Corrections - Renewal of License #37-19533-01

Description of Sealed Source

Telephone Deficiency-Renewal 37-19533-01

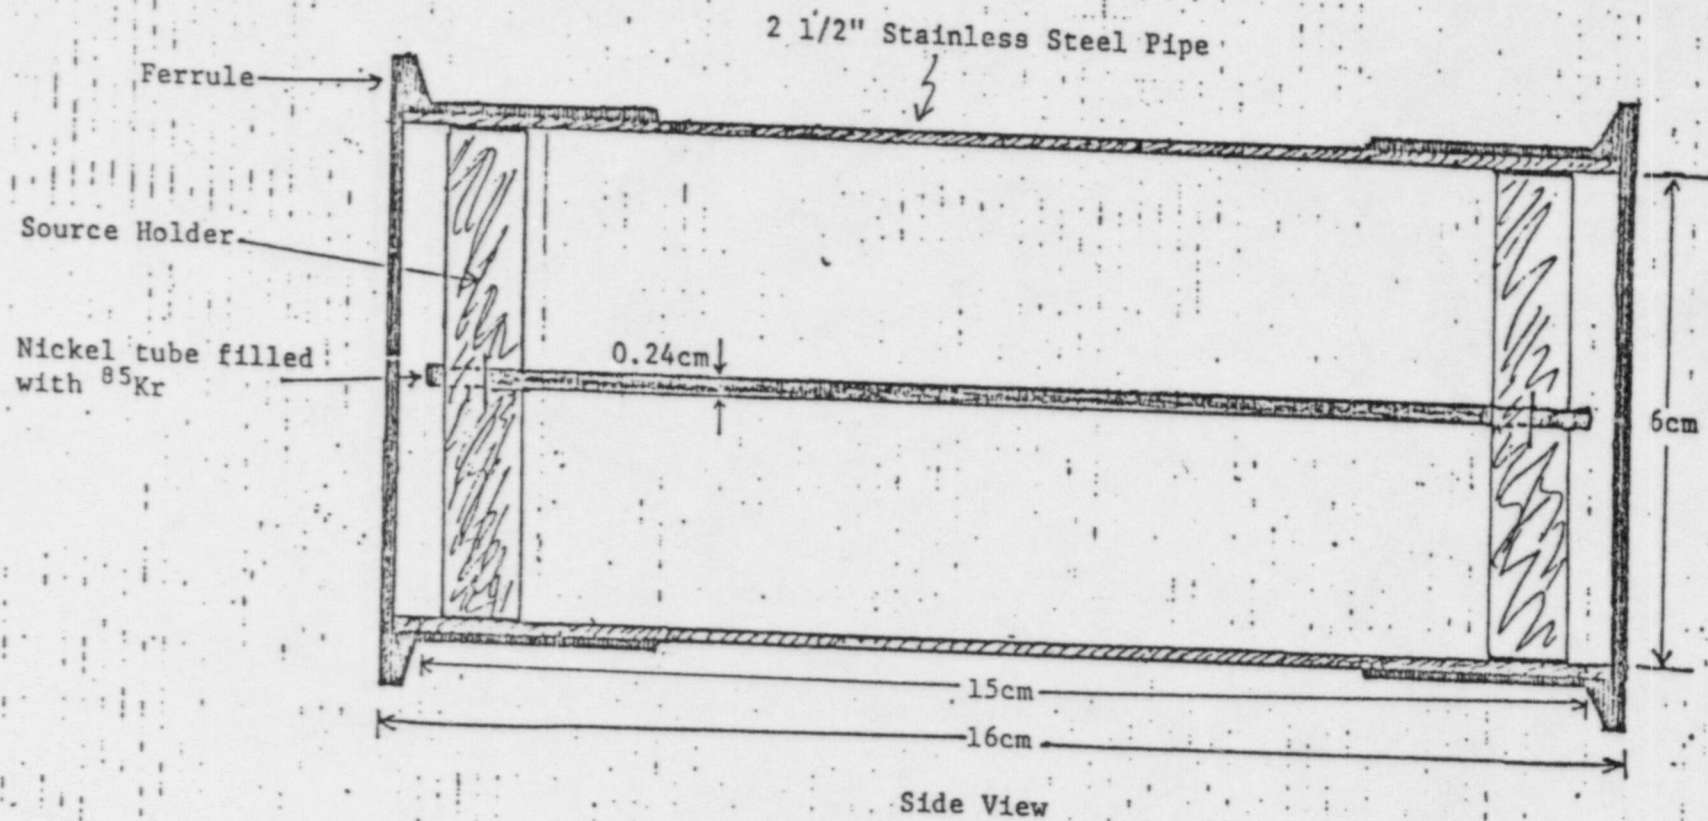
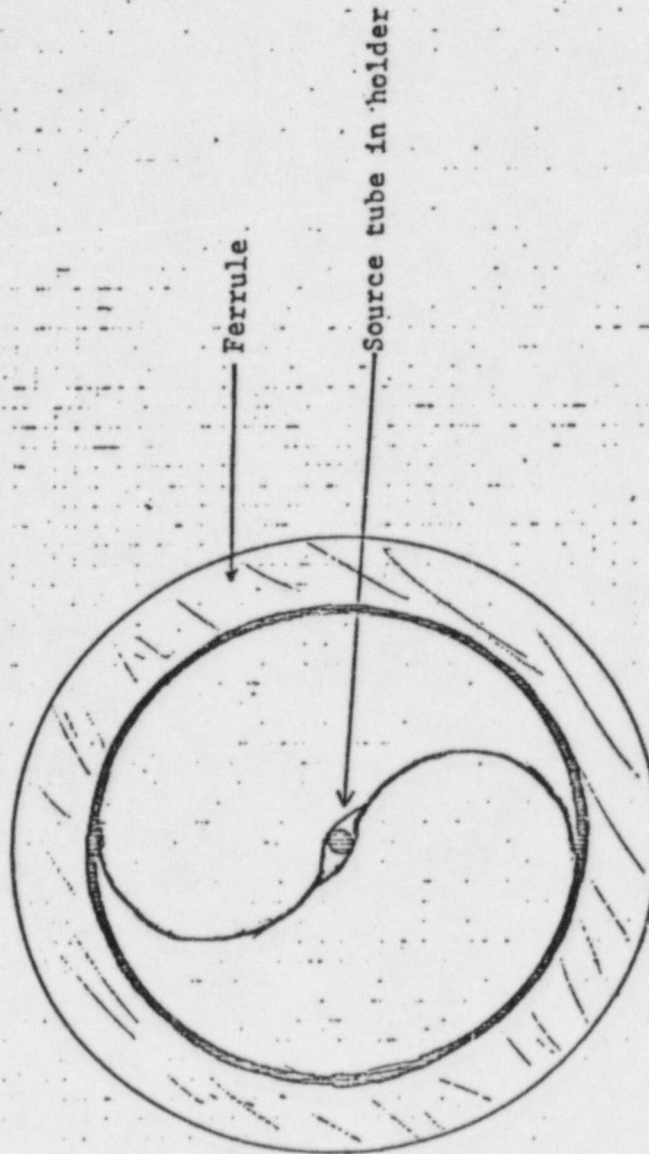
- 1- manufacturer & model # of aerosol neutralizer
Item 6:6 renewal application
- 2- manufacturer & model # of s.s. in aerosol neutralizer and
aerosol discharge devices
- 3- manufacturer & model # of GC & ECD
- 4- leak test procedures & instrumentation
- 5- number, manufacturers & model numbers of survey
instruments
- 6- Name of waste broker

Krypton 85 7 sealed sources similar to Amersham Capsule Model Xl62. Licensed material will be used for charge neutralization of aerosols and dusts in inhalation toxicology research. Leak tests on the sealed sources will be performed on a semiannual basis. Radioactivity will be detected by either a GM-Thin Window Meter, Mini Instruments, Model #5.10E, $0-2 \times 10^7$ millirens/hour or CPM or a Geiger Counter, Eberline Instruments Corp., Model E-120, $0-1 \times 10^6$ millirens/hr or CPM. Both are beta detectors. Description of Kr⁸⁵ sealed sources attached.

Stainless steel holders for the sources will be fabricated by the applicant according to the design of Teague, et al.* as shown in the attached drawings. The holders will be shipped to Amersham, Inc., Arlington Hts., IL, where sealed nickel tubes containing the krypton gas (similar to Amersham capsule X162) will be inserted in the holders. Amersham will then return the sources to the applicant.
